## DESCRIPTIVE REPORT

Registry No.                   F00541

General Locality           Bremerton

**ATLANTIC HYDROGRAPHIC BRANCH  
EVALUATION REPORT to ACCOMPANY  
SURVEY F00541 (2007)**

Figure 1.3.1

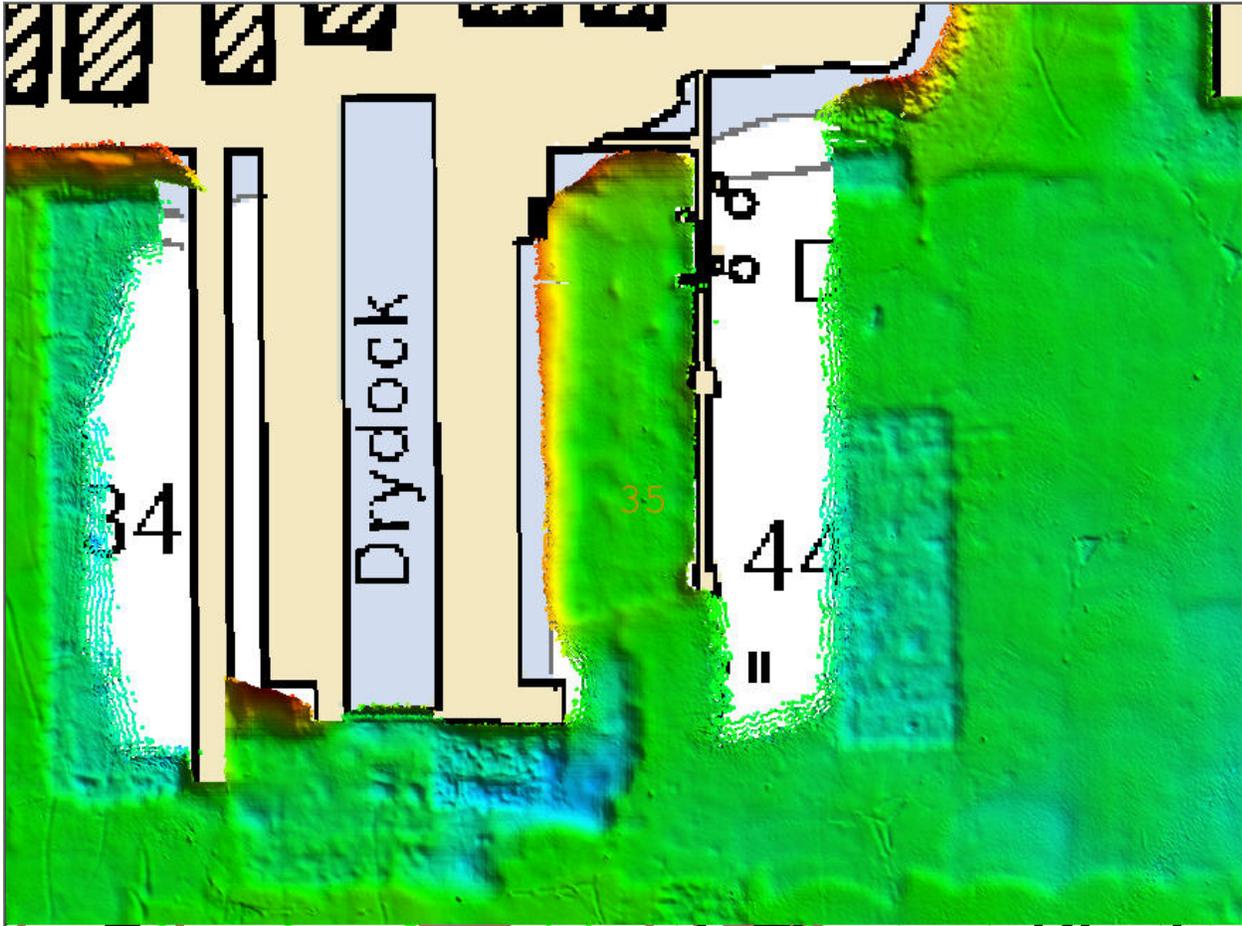
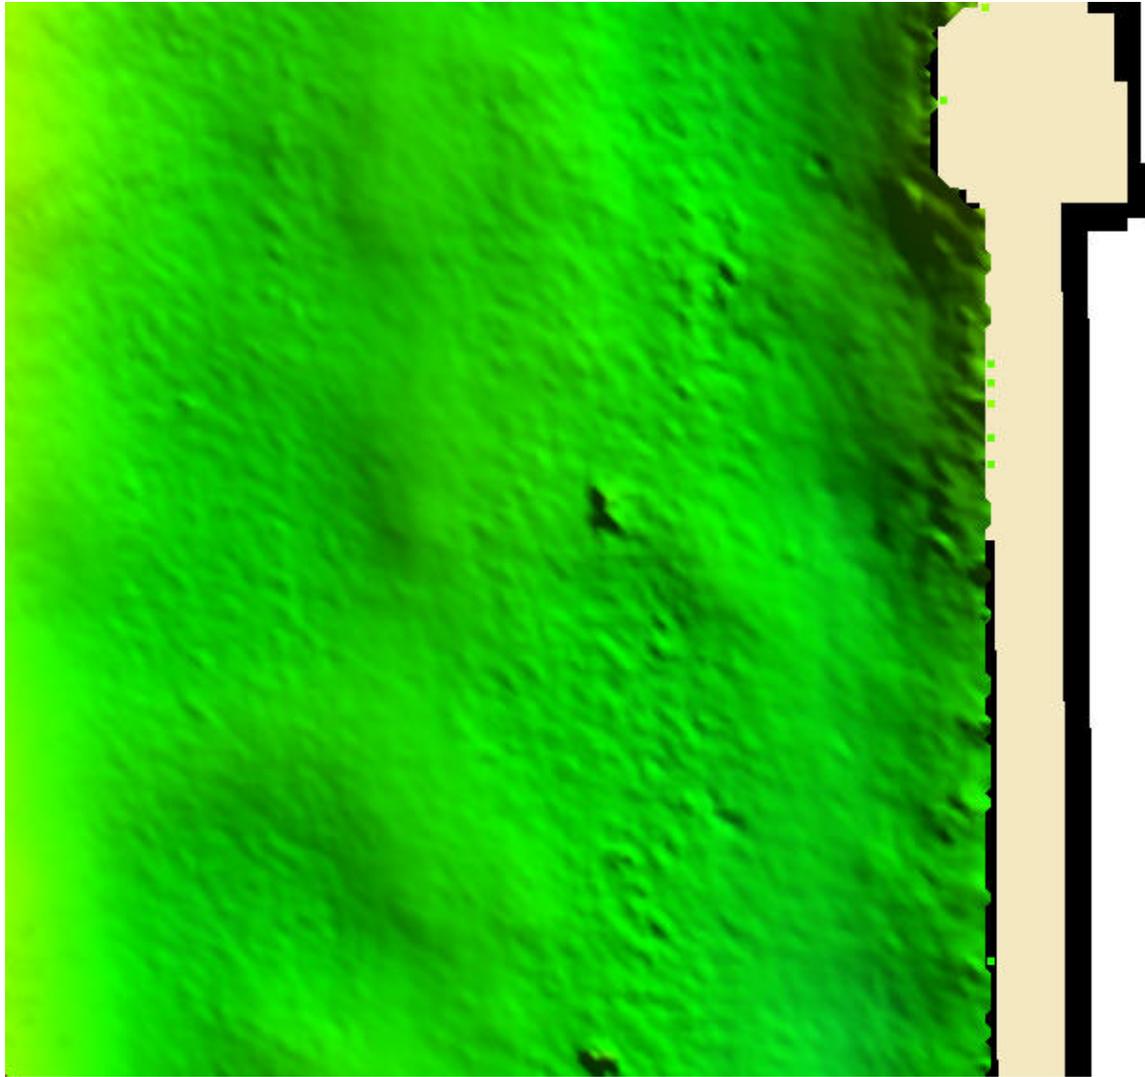
This 35-foot/10.65-meter submerged feature is not dense but was observed on two separate SWMB lines of hydro. It rises 6.8 feet/2.1 meters off the bottom and represents the controlling depth for the moorage slip.

Charted designated sounding

Concur. Dton previously sent to MCD, hence sounding is already charted.

Figure 1.4.1

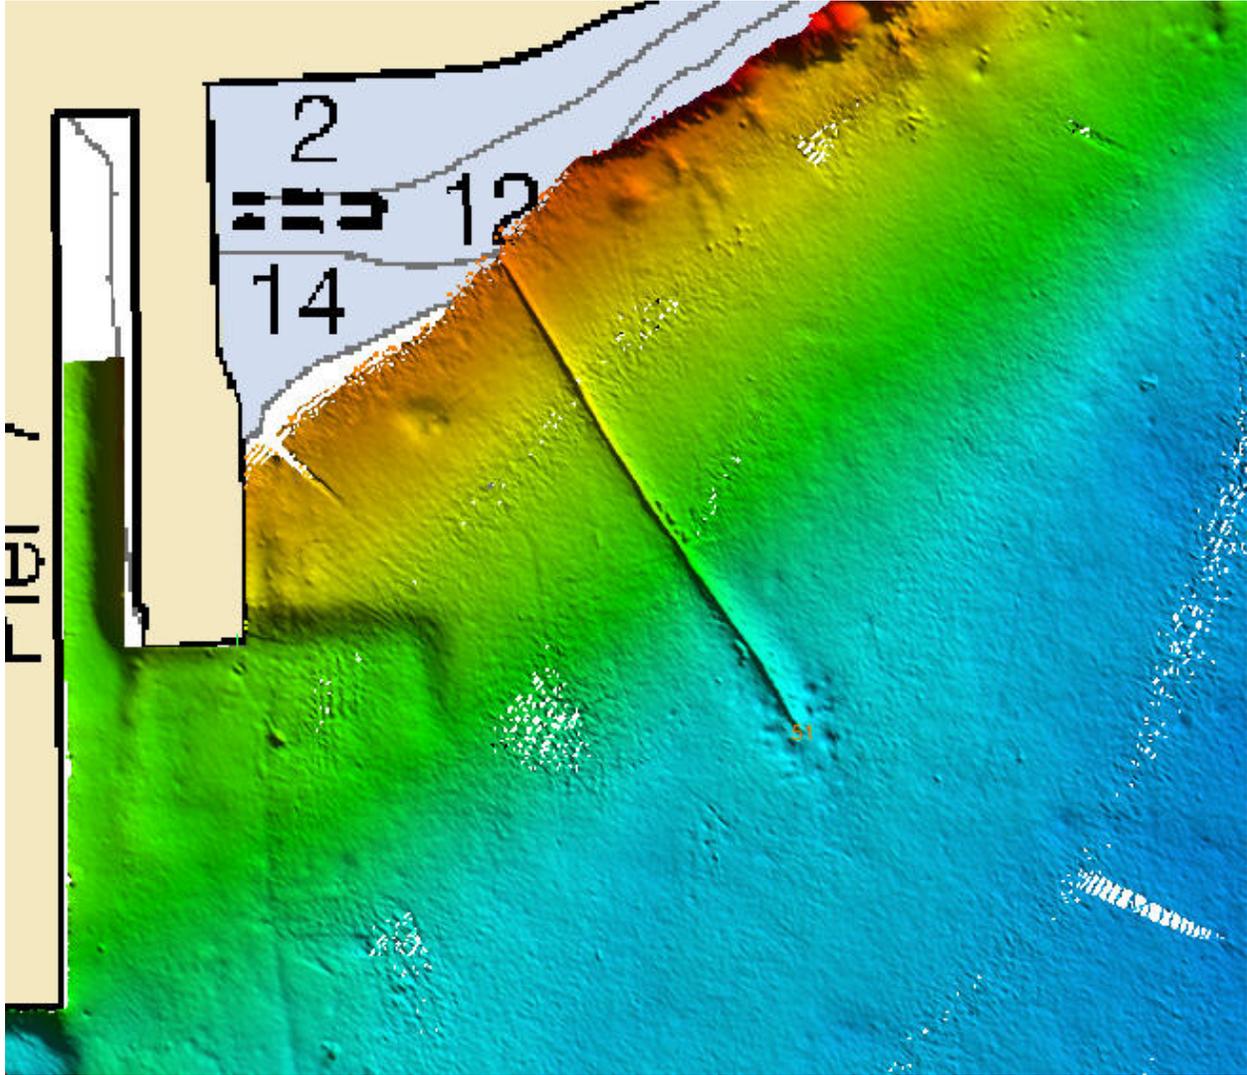
Designated sounding marks offshore end of an uncharted pipeline. Pipeline is not visible on shore but the feature as surveyed is oriented 318 degrees true.

Chart new pipeline as depicted.

Concur. Dton previously sent to MCD, hence pipeline is already charted.

Figure 1.5.1

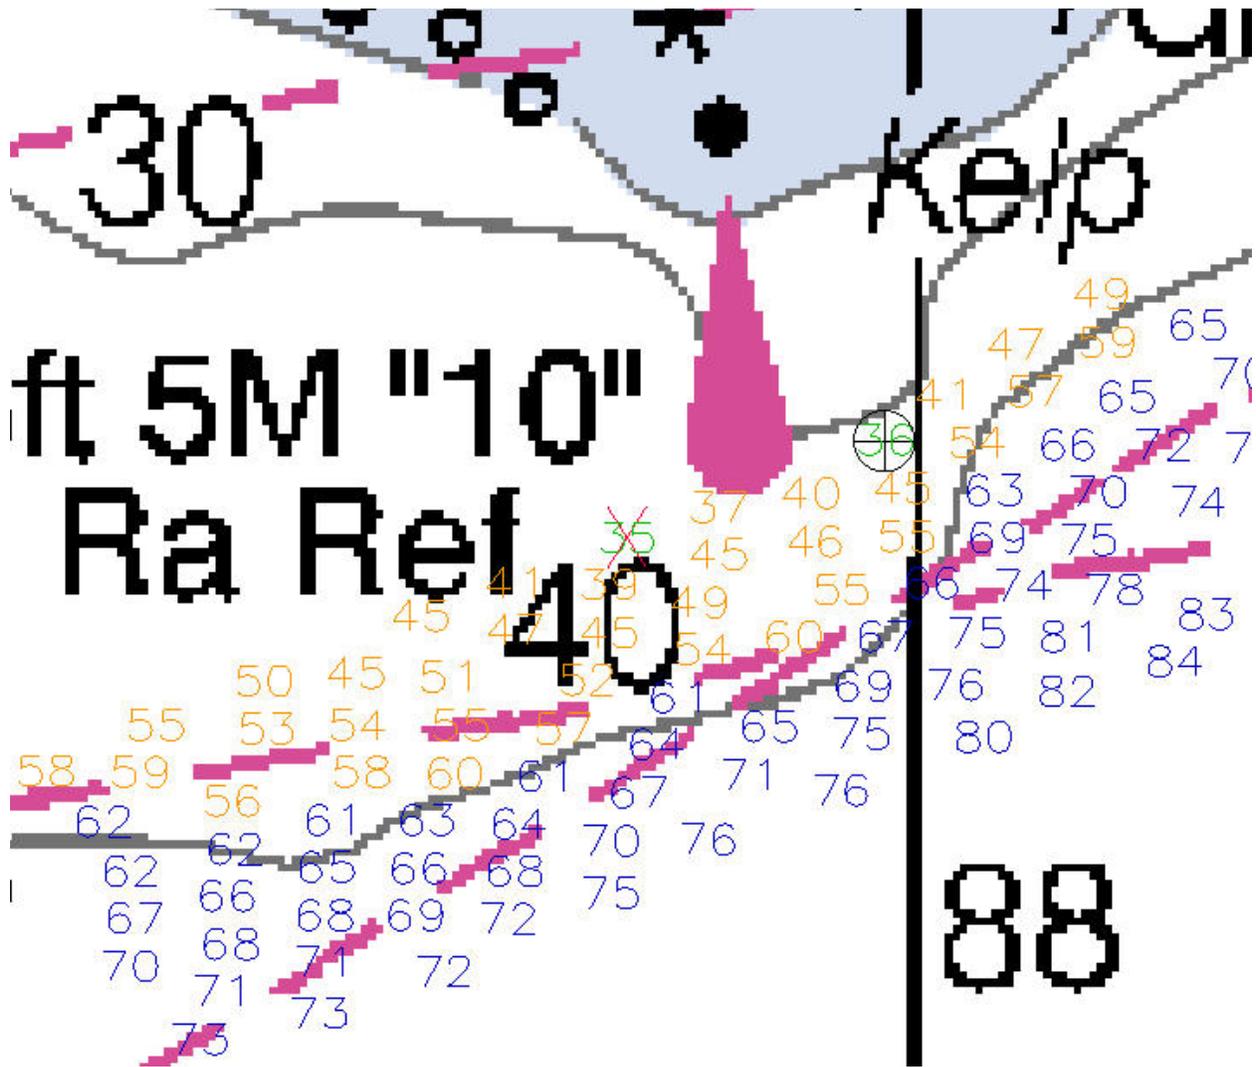
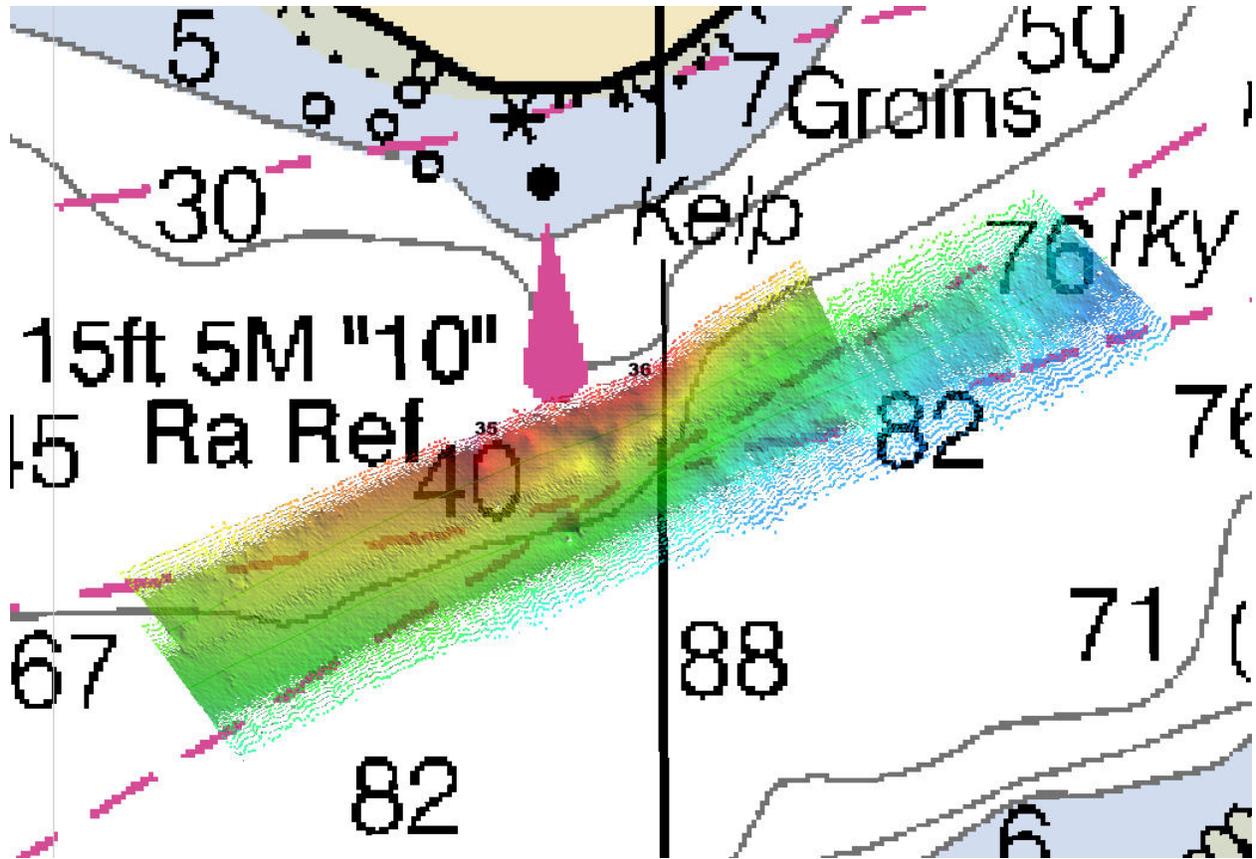
Shoal 35-foot sounding adjacent to charted 40-foot sounding

Chart designated sounding

Concur. Dton previously sent to MCD, hence sounding is already charted.

Figure 1.3.1

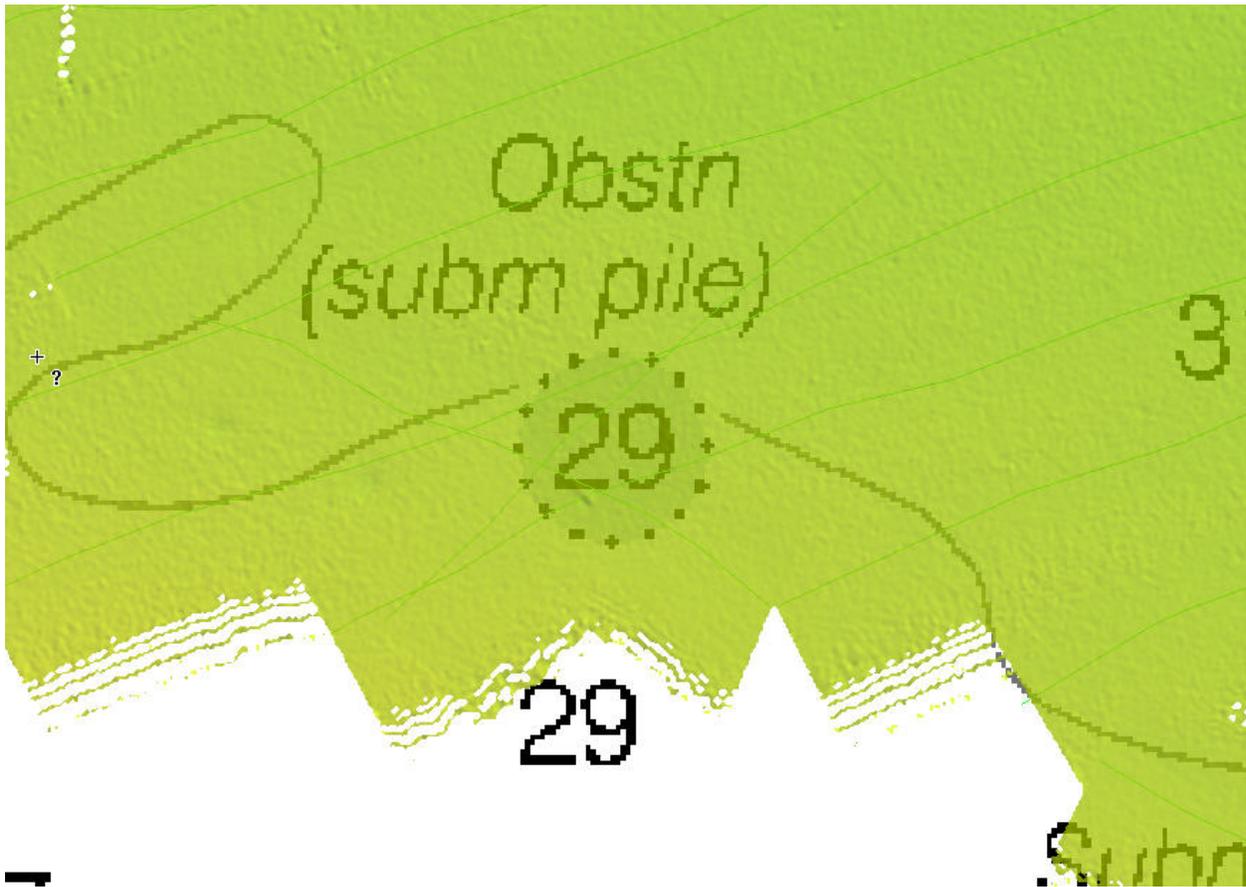
A small, insignificant stump rising one foot off the bottom was located with SWMB at position of AWOIS #50728.

Delete charted obstruction and text "Obstn (subm pile)". Chart soundings from current survey.

Concur.

*Figure 1.4.1*

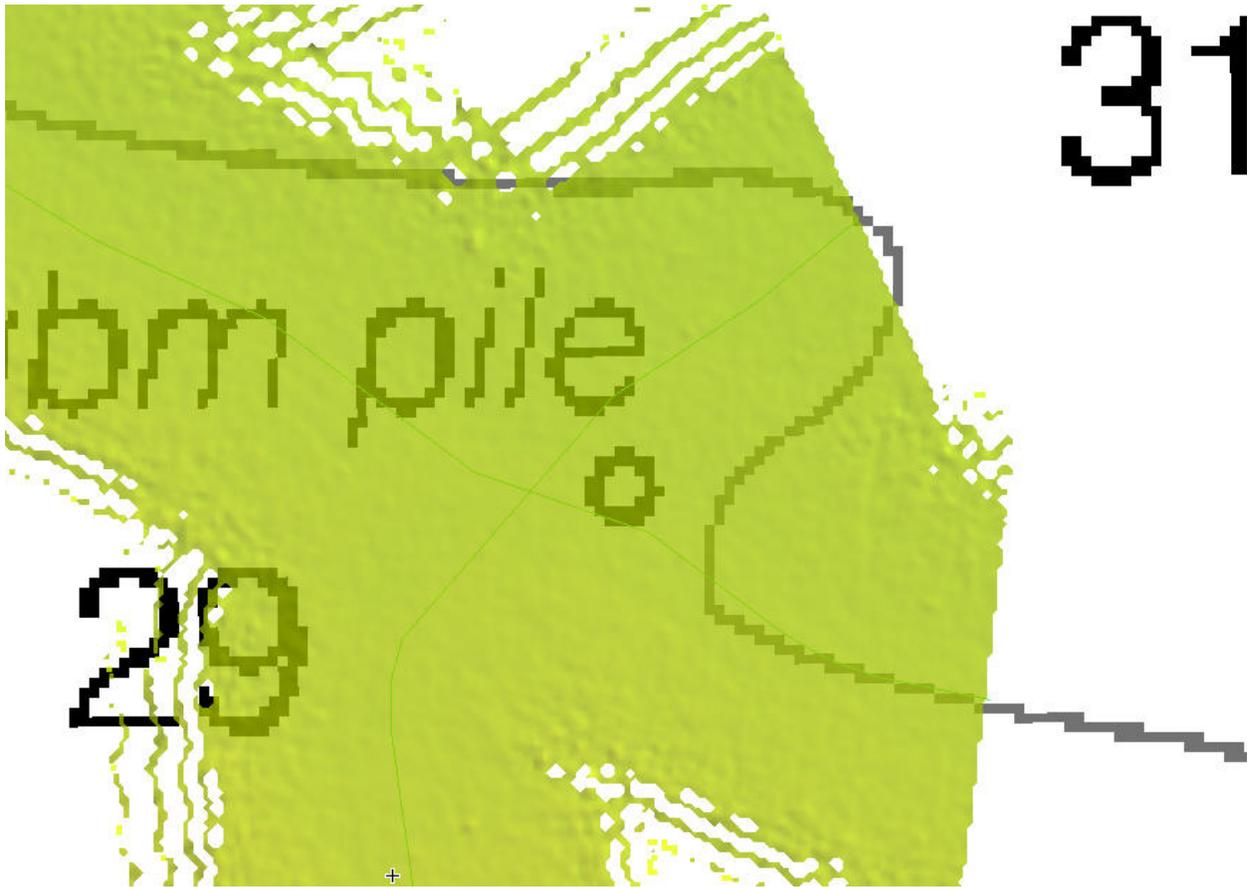
Object detection SWMB coverage was acquired over the target location out to a radius of about 35 meters. No obstruction was found.

Given that there is no evidence that the charted position was 'PA' combined with the age of the report and the findings of this survey, the hydrographer recommends deleting the charted Subm pile and text and charting the soundings from the current survey.

Concur.

Figure 1.5.1

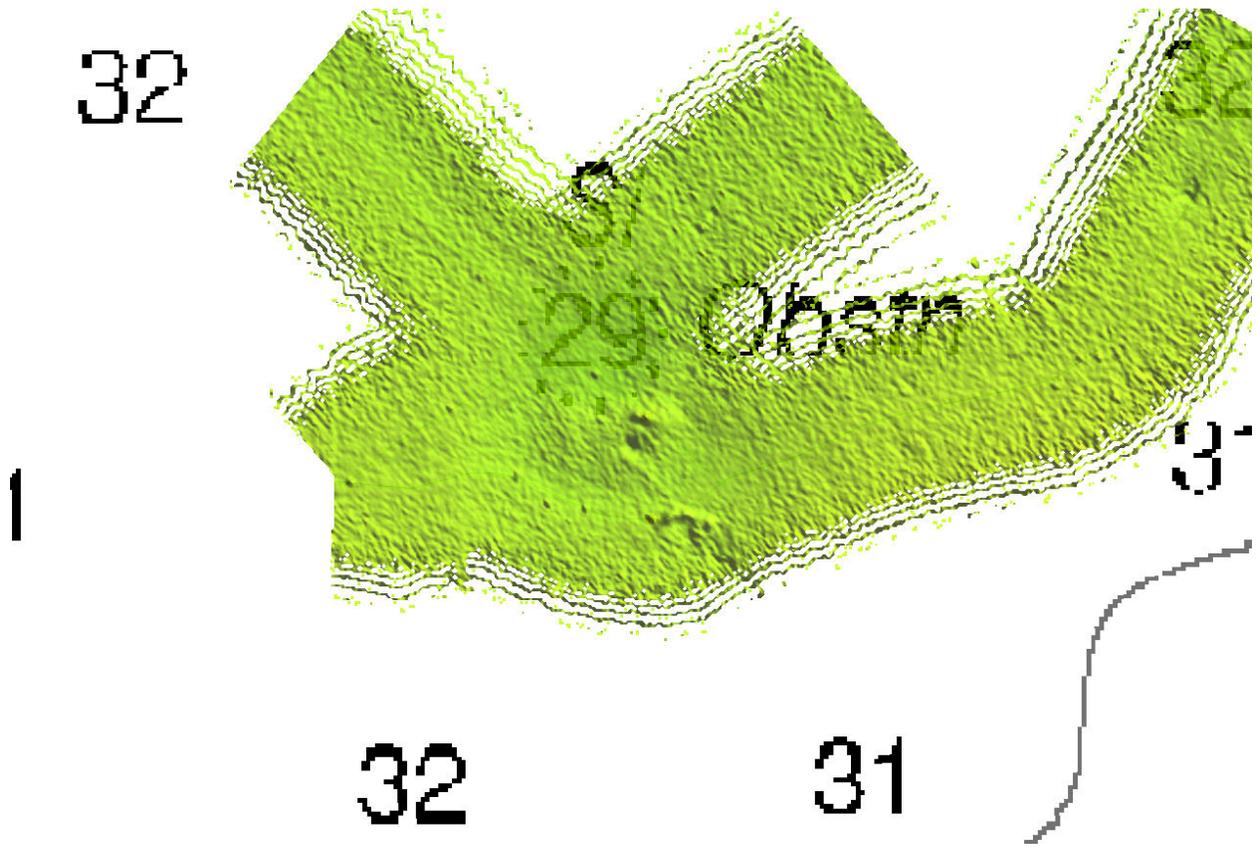
No obstruction was found

Delete sounding over obstruction and "obstn" text. Chart soundings from current survey.

Concur.

Figure 1.6.1

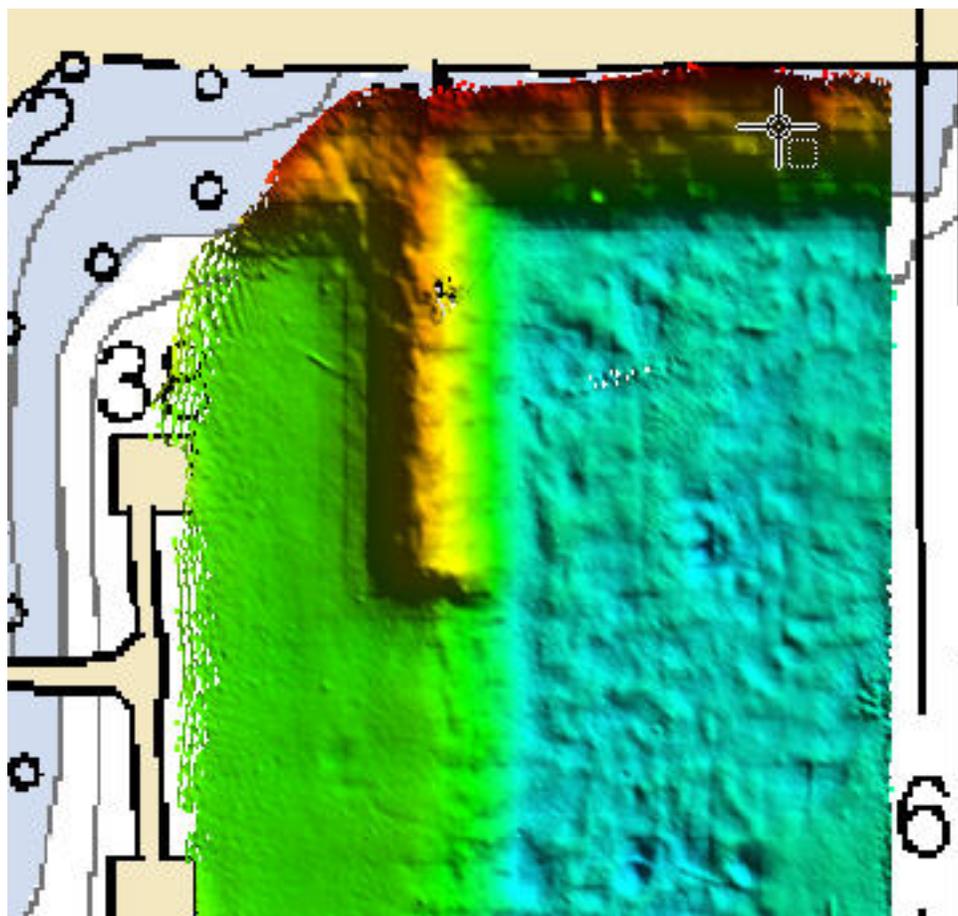
Findings: Remnants of the pier remain; Charted piles at the end are not visible.

Retain and extend charted ruins to include charted piles at offshore end

Concur.
